## Chief Executive's Report

Response to An Bord Pleanála in accordance with the requirements of Section 8(5)(a) of the *Planning and Development (Housing) and Residential Tenancies Act 2016*

ABP Case Number: TA29N.314019

**Development Location:** At the Junction of Santry Avenue & Swords Road, Santry, Dublin occupying the site of the existing Chadwick Builders Merchants

**Figure 1: showroom/offices in question marked with a cross**

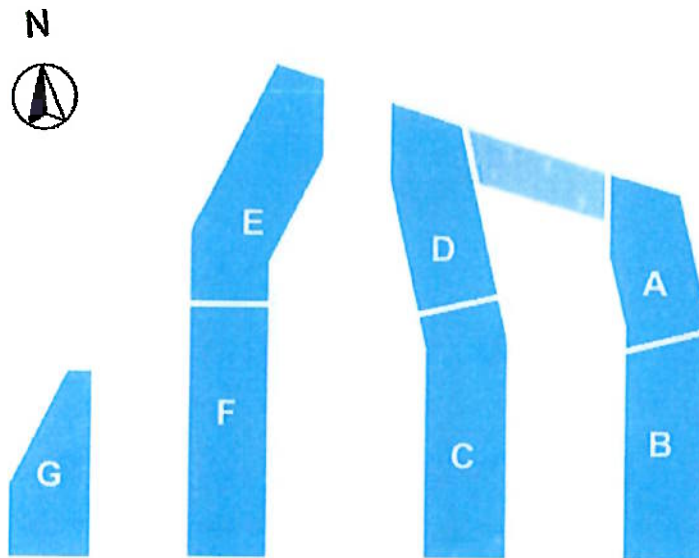
The part of the building in question is set back from the site boundary on Swords Road by between c. 15 and c. 34 metres, with a setback of between c. 20 and c. 29 metres from Santry Avenue to the north. It is largely single-storey, and has an area of c. 1100 sqm. The retention of this portion of the building would create a considerable constraint on the site. Notwithstanding the attractive nature of the building, and notwithstanding the submission from Chadwicks, it does not constitute an efficient use of serviced zoned land in a built up area, having a low site coverage, and a low plot ratio.

As such, given the existing policies (both at city level, in the Dublin City Development Plan 2016-22) and at national level on intensification of use and density in built up areas, the retention of this building (which has not been included in the National Inventory of Architectural Heritage, is not a protected structure, and is not being proposed as a protected structure) is not justified, and its demolition is considered acceptable.

**Figure 3 Proposed public open space diagram**

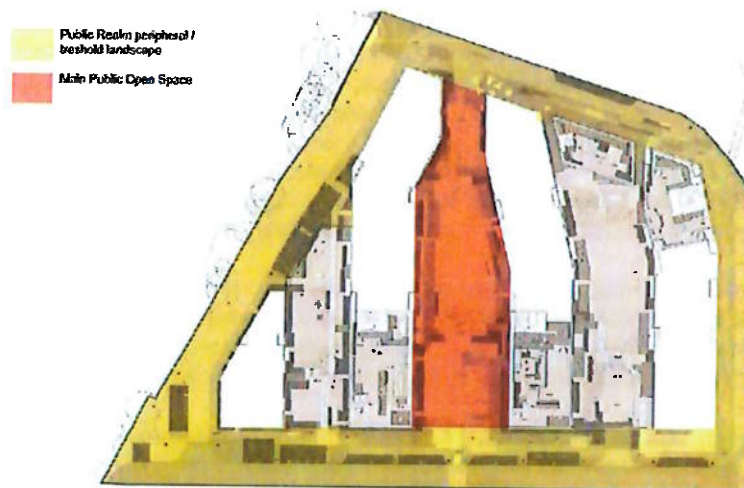
The proposed public open space diagram (below) indicates public open space measured up to the buildings facades. This is not an acceptable approach as a buffer strip as communal /private open space is required for all ground level apartments. The calculation of public open space may therefore need review by ABP (a shortfall, if any, may be addressed by a financial contribution in lieu). The planning authority estimates that approximately 1575 sq.m. of public open space has been provided i.e. the minimum required in terms of quantity.

In terms of quality, the space is well connected with Santry Avenue with relative ease of continued pedestrian access into Santry Demesne Park and good visual connection with same while also achieving good connections with the large area of public open space to the south of the site at Santry Place. A coffee shop is proposed in this development opening into the area of open space, thereby increasing its overall attractiveness. Furthermore, the space is of good orientation i.e. south-facing. The Sunlight Analysis indicates that all areas of outdoor amenity space receive excellent results with the 'worst case' i.e. surface communal amenity space between Blocks F and G showing that 70% of this space will receive at least 2 hours of sunlight on the 21<sup>st</sup> March, well in excess of the 50% minimum recommended standard. All other areas of outdoor amenity achieve results of over 86% and above.
